Re: CPV Sentinel Energy Project: Docket No. 07-AFC-3

# Responses to Data Requests #66 – 97

## Application for Certification (07-AFC-3) for CPV Sentinel Energy Project Riverside County, California

**FIGURE 71-1**

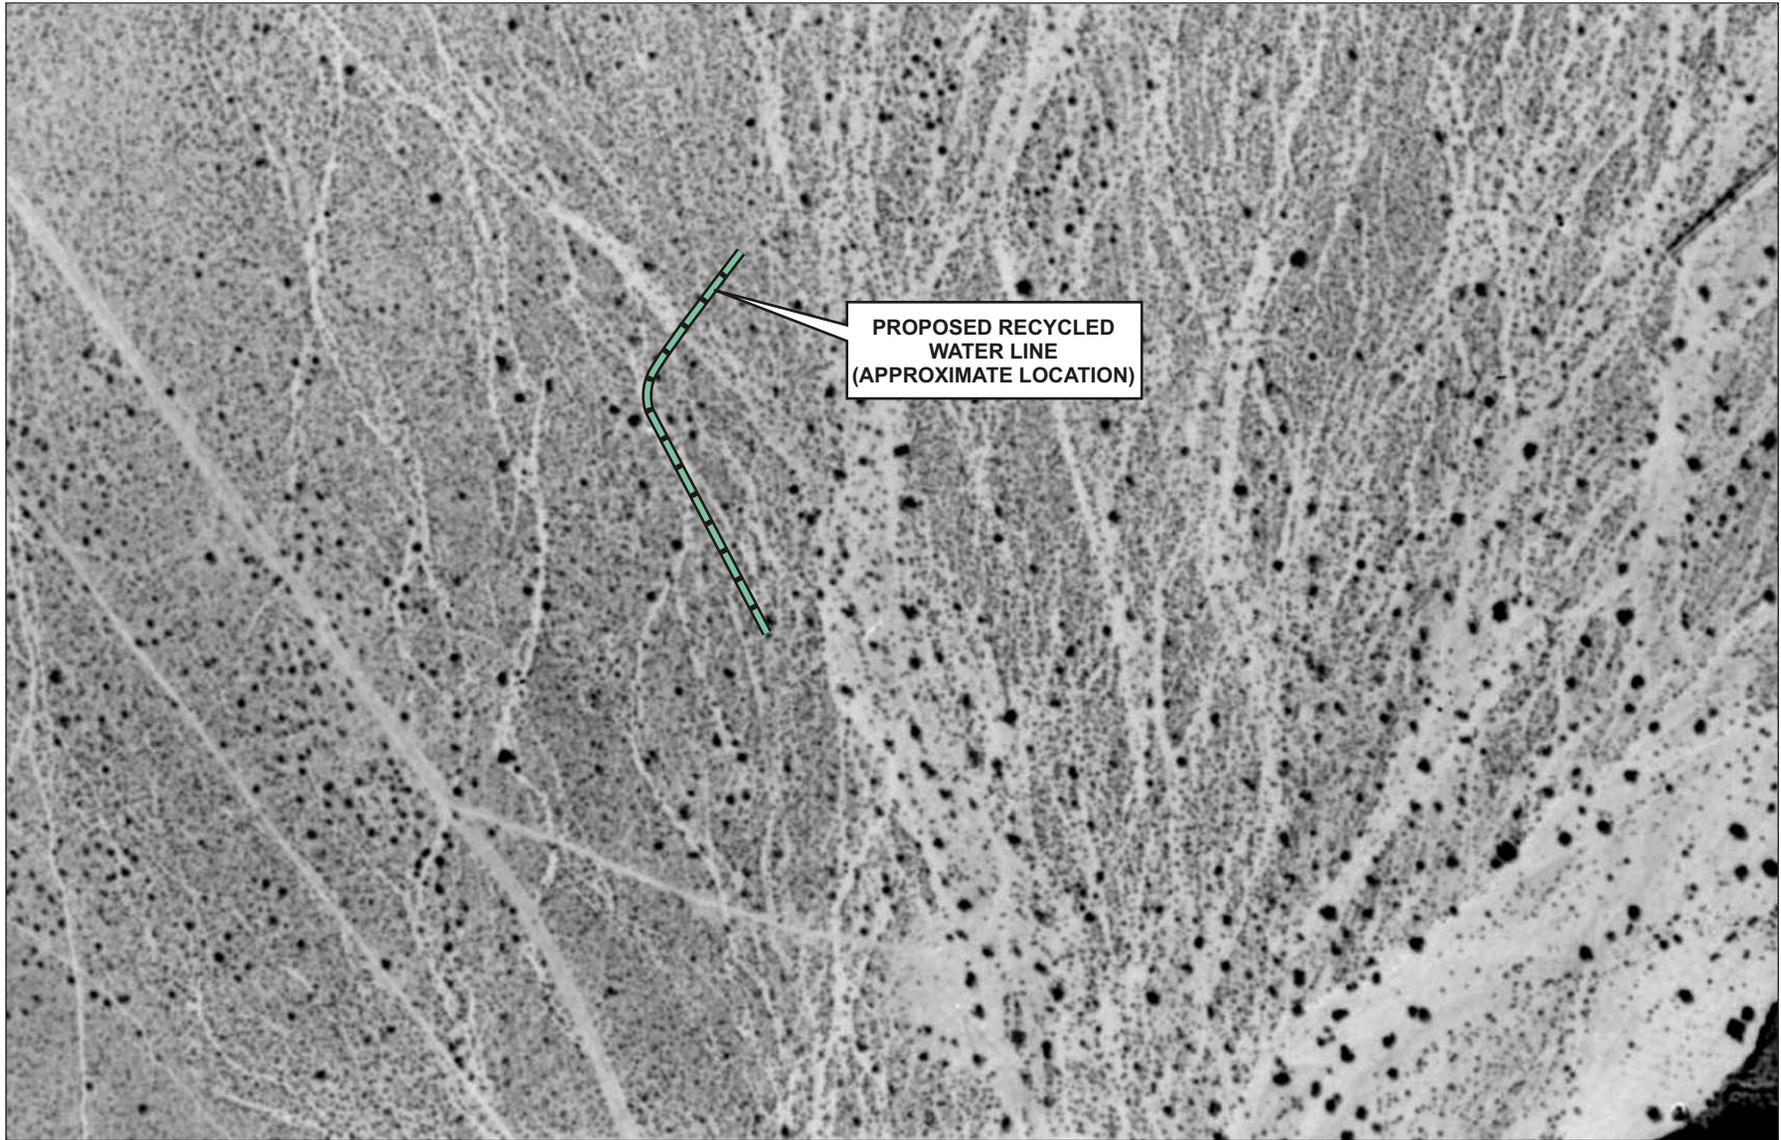
***71. Please provide copies of the aerial photographs that were examined to make the decision that no survey was needed, as well as any earlier photographs of the area that may be available.***

Figure 71-1 shows an aerial photograph taken in 1953 and the approximate location of the proposed recycled water pipeline. This aerial photograph is the earliest photograph obtained for the area, and predates development of the Palm Springs National Golf Course in 1960-61.
